Response to Public Submissions

DA 21/11288

Perisher Views Ski Lodge
Lot 1, DP1192372
Burramys Road, Perisher Valley

Geoanalysis Pty Ltd

Oversnow route following Burramys Road during 2020 season

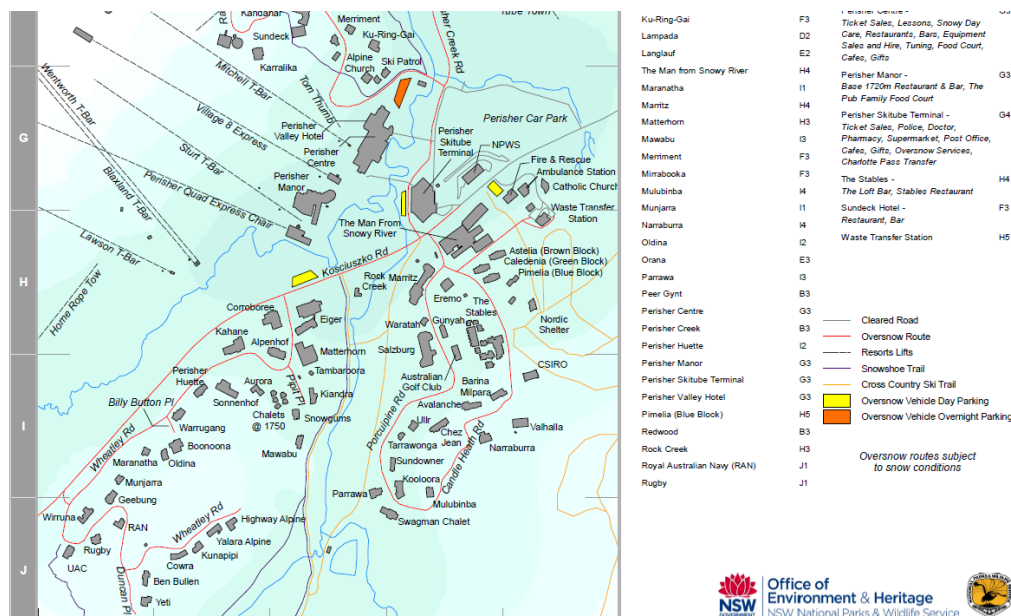
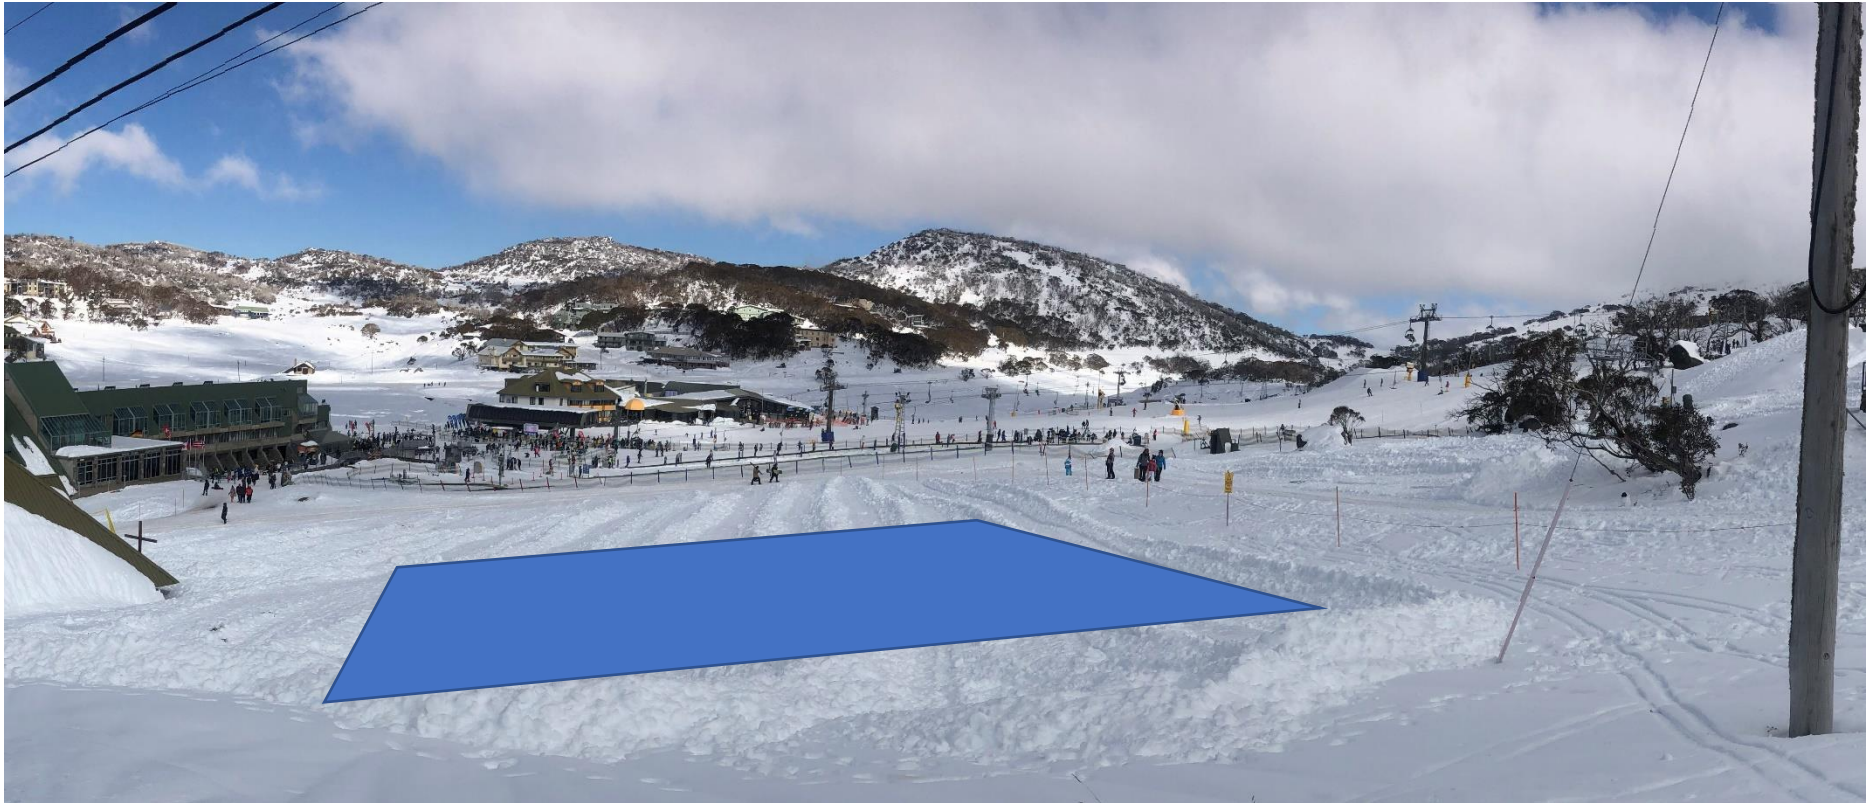
Several submissions state that the oversnow route passes through the Perisher Views lot. Whilst vehicles may cut the corner of the lot during good snow years (saving a few seconds), the legal oversnow route exactly follows Burramys Road and is limited to a speed of 30km/h. Oversnow routes are identified in the document *Alpine Resorts Winter Access Kosciuszko National Park* (Office of Environment and Heritage, 2018), Appendix A (see below).

Suggestions that building on the Perisher Views lot will force access to lodges uphill of Perisher Views along Perisher Creek Road past Yaraandoo lodge, to the north thereby pushing up travel times, oversnow fares and slowing emergency response times are misleading and simply untrue. In the 2020 winter season, the Perisher Views lot was roped off and the oversnow route was correctly located on Burramys Road. The photos on the following pages show this occurring, as well as groups of people walking or riding along the oversnow, sharing this with vehicles.

Notwithstanding the above, the proposed western deck has been removed and the building modified providing a minimum setback of 3 metres from the western boundary of the lot, which equates to a distance of approximately 5 metres from the road.

When the oversnow route follows Burramys Road it is a very gentle slope and a straight run past Perisher Views with good sight lines. It is common throughout Perisher for oversnow vehicles to share oversnow routes with skiers, indeed this occurs for the length of Burramys Road uphill of Perisher Views.

3.Aesthetics and Impacts on KAL views

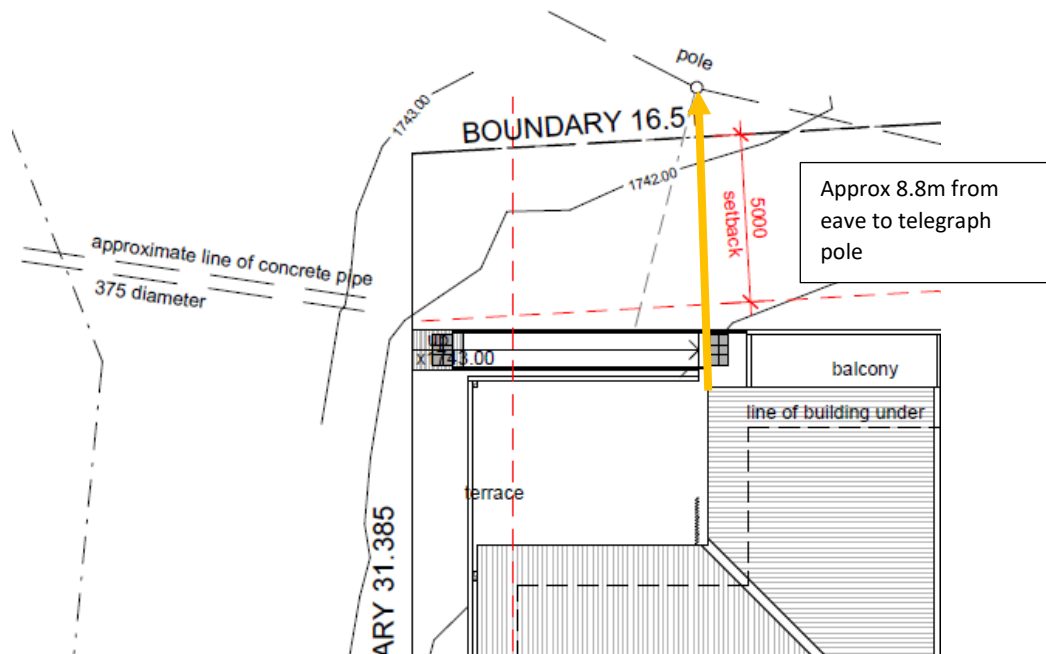
The KAL submission (following page) shows the building extending to the telegraph pole, however as can be seen below the building is approximately 8 metres from the telegraph pole. The KAL submission also shows the first floor of the building extending well above Burrarmys Road, whereas the RL of 1743.50 is 10mm below Burrarmys Road where the stormwater drain is located. The KAL submission grossly overstates the impact on views.

The property has been designed to be largely setback behind the trees between KAL and Perisher Views. The north-western corner has been further recessed from the boundary to specifically reduce the visual impact to KAL, such that the property will be barely visible from the KAL kitchen window.

The design has been further modified since the initial DA was lodged to provide a 3 metre setback from the western boundary, further reducing its visibility from KAL.

Significant effort has been put into minimising impacts on the views to KAL including recessing the north-western corner of the building, whilst also maximising the setbacks from the Alpine Church. As shown on the following page the proposed lodge will not impact on the views across front valley to Mount Perisher from KAL's kitchen window. The proposed building will be barely visible.

stage: Development Application
sheet: Equinox Shadow Diagrams
drawn by: YY
approved: Checker

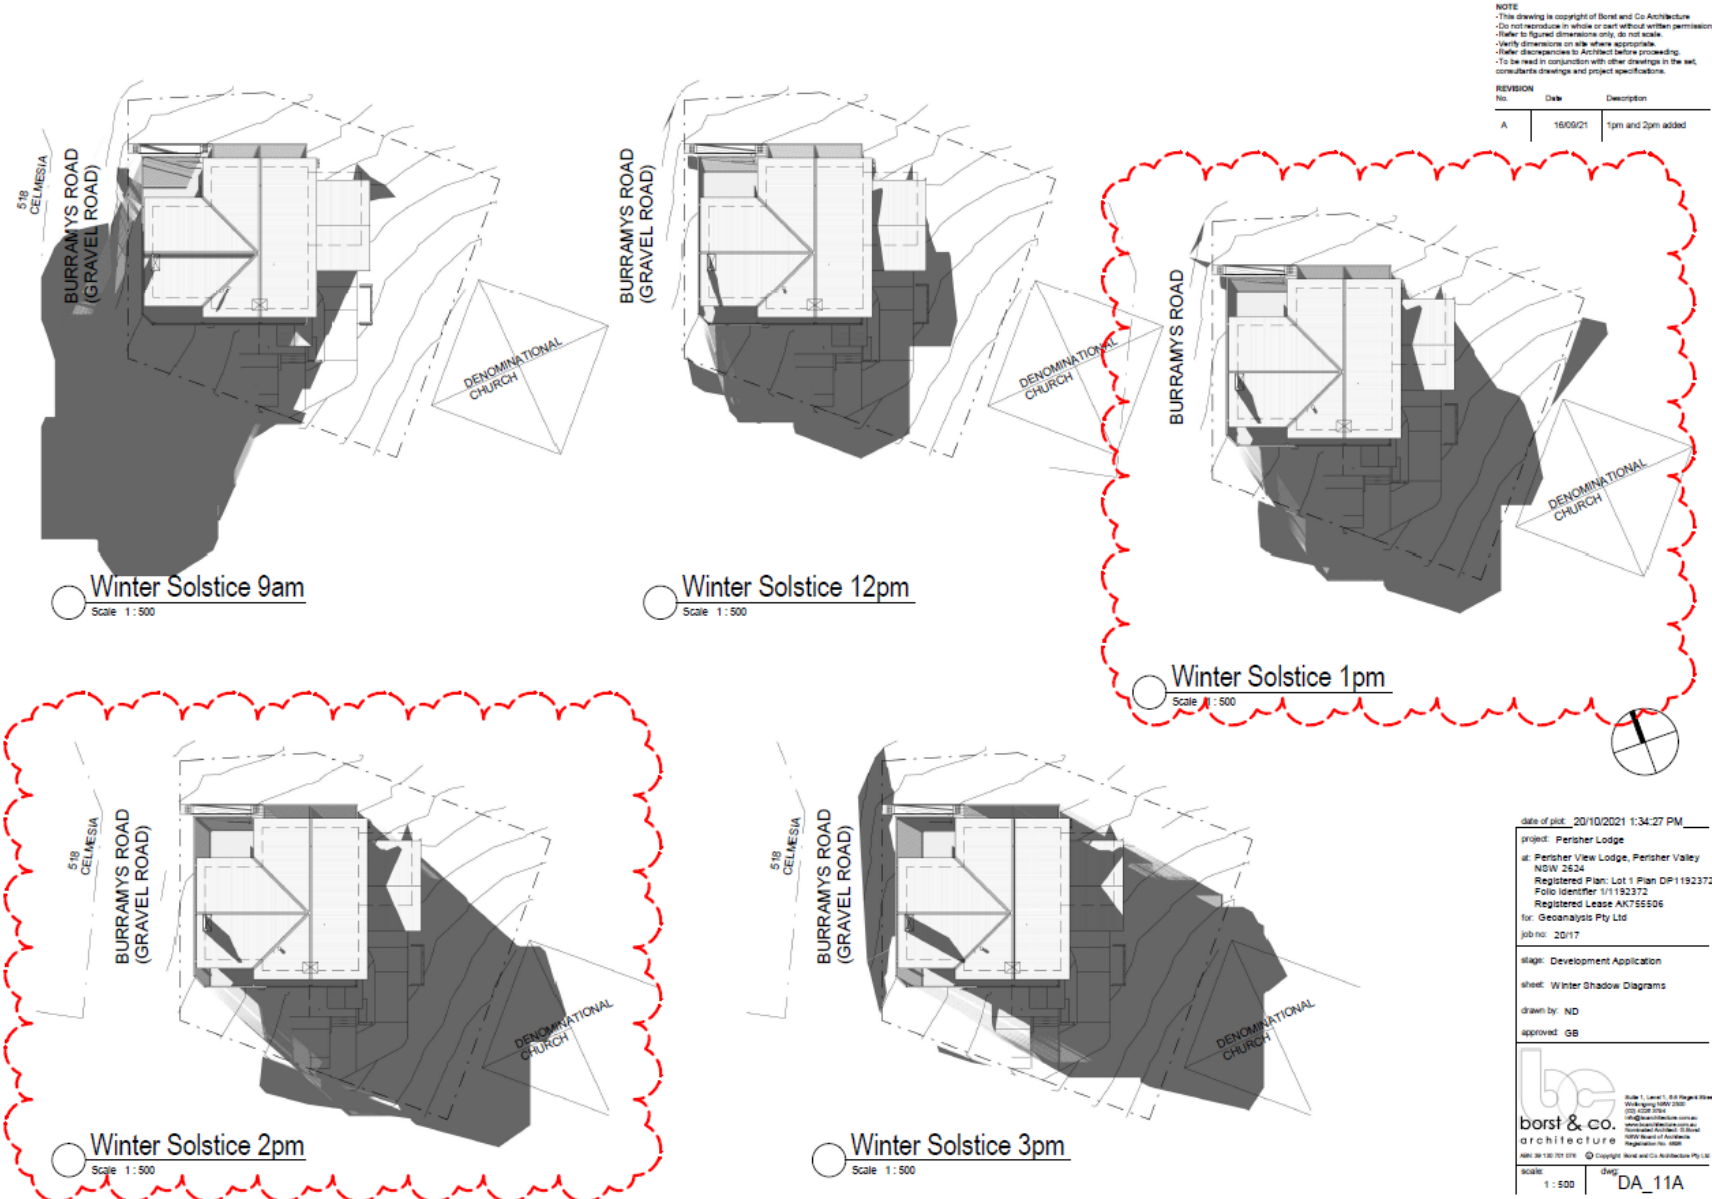
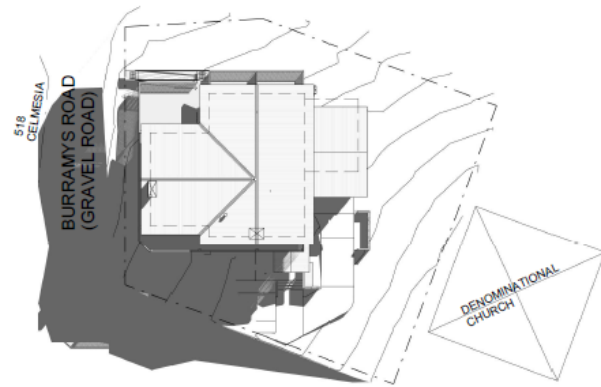
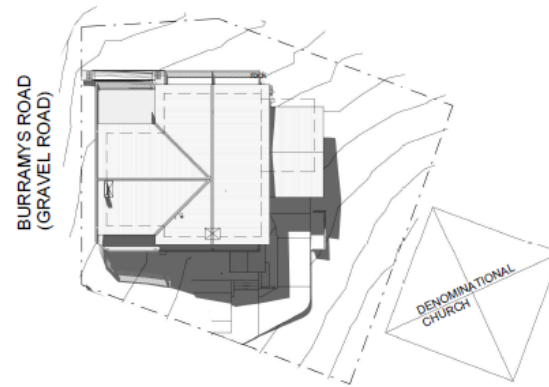
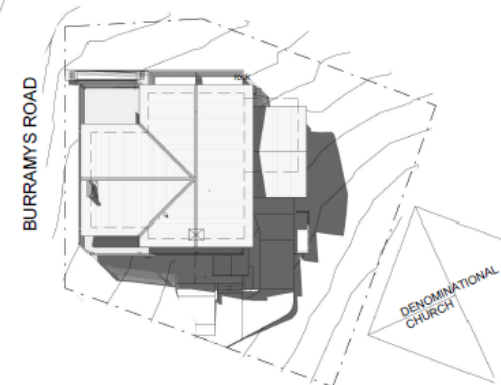
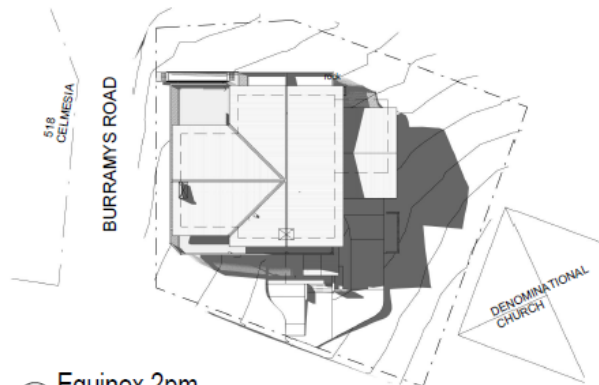
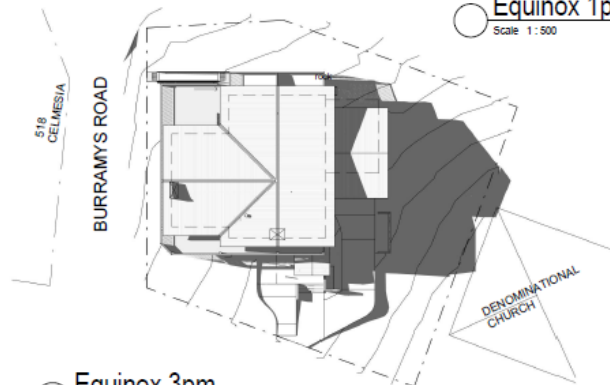
4. Overshadowing of Alpine Church

To minimise impacts on the church the proposed lodge has been relocated as close to the western boundary of the development as allowable, rotated on its axis to optimise the church prominence to front valley and the building form stepped down the slope to minimise impacts on the church.

The winter solstice occurs early in the season (typically around the 22nd June) and overshadowing of the western wall of the church commences at approximately 1pm, occurring later in the day each day thereafter. Church services occur from 12.30 to 1pm every Sunday. By the time the northern window is affected at approximately 3pm, the sun has likely set behind the ridge due to the low height of the sun at this stage of the season. The spring equinox occurs later in the season (around 22nd September) and overshadowing of the western window at this later stage of the season starts after 3pm (shadow diagrams are provided on the following pages). Three (3) hours of sun on the solstice is a common planning standard in NSW, with the sun rising before 8am on the solstice the church would receive in excess of 5 hours of sun.

The western window of the church is recessed behind the roof structure and it isn't uncommon for it be buried in snow, blocking much of the light from this aspect (see photos below). Overshadowing is likely to be minor and will occur outside of church service times. The photomontage on the following pages provide us a good idea of how well the proposed building fits in with the existing form.
